Comment-

Horse Heaven Wind Farm Ferruginous Hawk Nest Mitigation Plan

Dave Sharp

Tri-Cities CARES

Figure 6. Comparison of estimated annual diurnal raptor use during fixed-point large bird use surveys at the Four Mile Wind Project from June 5, 2018 – May 29, 2019 and diurnal raptor use at other Oregon and Washington Wind Resource Areas with similarly collected data.

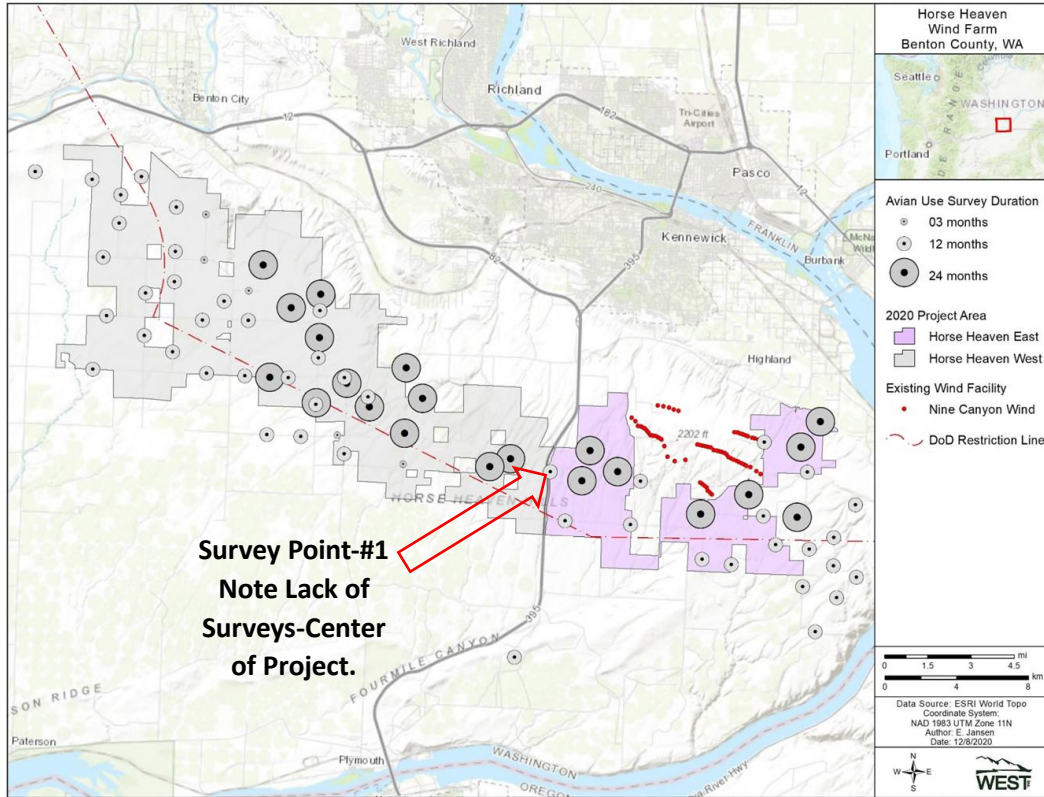
- The East portion of the Project, formerly called Four Mile East, had Avian Mean Use Surveys (AMUS) for diurnal raptors among the highest of surveyed projects in the Northwest. See **Attachment 1** from Appendix K-Four Mile Avian Use Report.
- The area in vicinity of I-82 was under surveyed. See **Attachment 2** from Appendix M Bird and Bat Conservation Strategy showing lack of surveys in the central project area.

Figure 5b. Flight paths of diurnal raptor subtypes recorded during large bird surveys at the Four Mile Wind Project Study Area from June 5, 2018 to May 29, 2019.

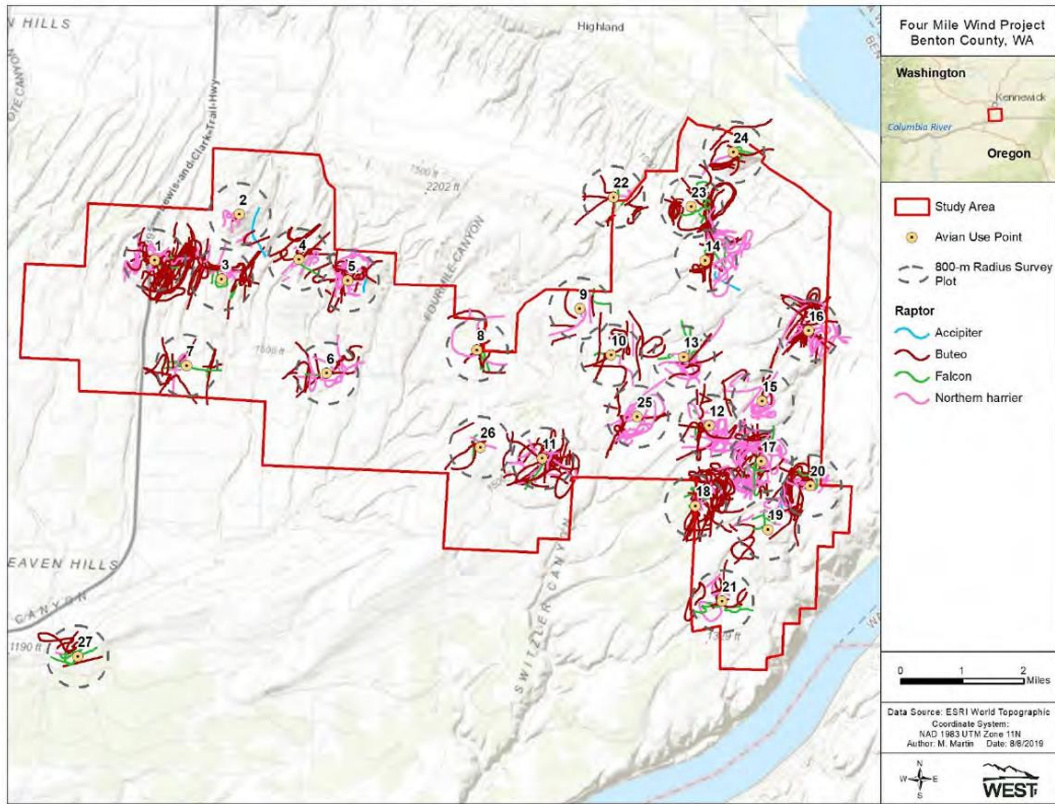
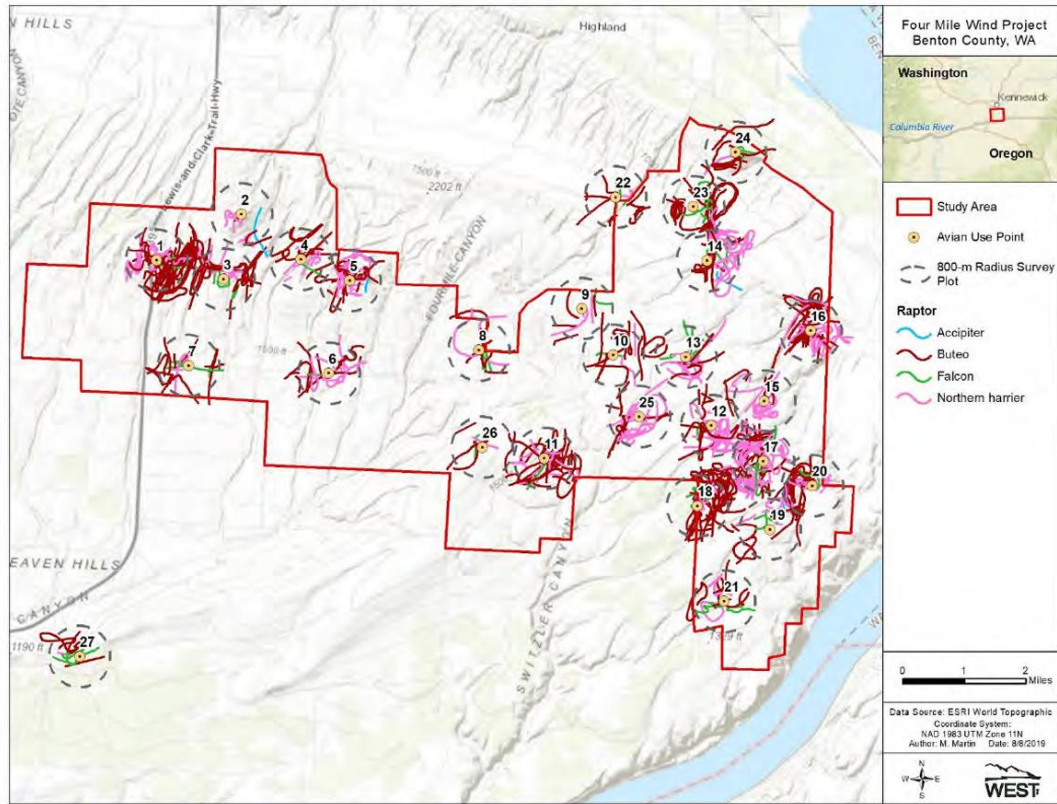
- The single survey point immediately east of I-82 shows the highest buteo and diurnal raptor use across the entire site. See **Attachment 3**, also from Appendix K -Four Mile Avian Use Report. This shows the flight path activity of Buteos just East of I-82. For whatever reason, that area is heavily used for foraging. The Four Mile area also had high populations of American White Pelican, snow geese, sandhill cranes, and other species under protection of the Migratory Bird Treaty Act.

- If taller turbines are selected, PTAG should recognize that the area just East of I-82 in the Johnson Butte area as mentioned above are high mean use for Buteos.
